UNITED STATES PATENT AND TRADEMARK OFFICE

10/578,330

Office Action Summary	Application No. 10/578,330	Applicant(s) WALLSTEN, STEN	
	Examiner Jeremy Severson	Art Unit 3653

DETAILED ACTION

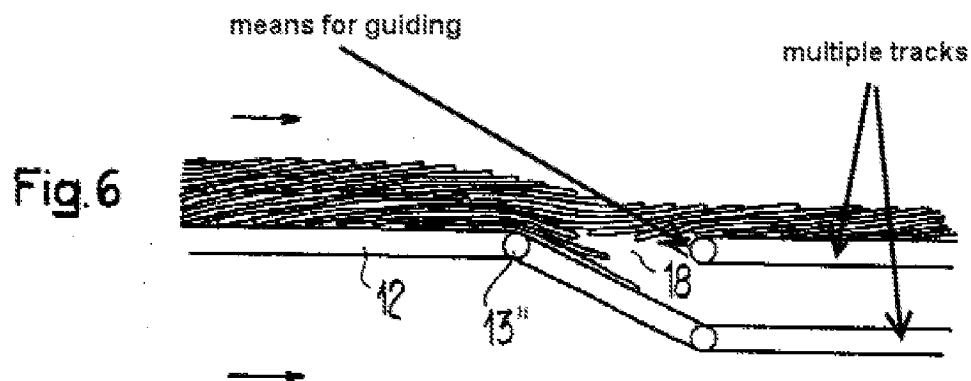
Regarding claims 1 and 2, Dietrich discloses a method of storing printed products in one or more layers, the method comprising: storing the printed products on at least one substantially circular conveyor track (19); supplying the printed products (from stack S) to the conveyor track at least at one point in the track and discharging the lowermost layer from the conveyor track through an opening in the track (18); the supplying and discharging of products being independent of each other, wherein printed products are supplied to the track while at the same time printed products are discharged from the track at the opening.
